## HARTING Product Termination Notification

Business Unit: HARTING Electric PTN/22/004/C+N-US

Product Range: Han EMC Date: 02/01/2022

**Title:** Phase out of PG Threaded EMC Variants

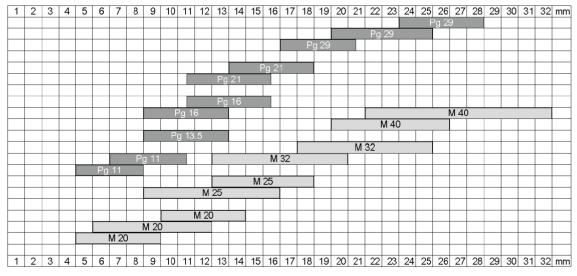
The standard for PG threads, DIN 46320, has been withdrawn in the year 1999. It has been replaced by the international standard for metric threads, IEC 62444. To apply this change, we will discontinue all parts with PG thread in the Han EMC range and recommend using metric threads. To replace a PG thread by a metric thread, the following diagram can be used:
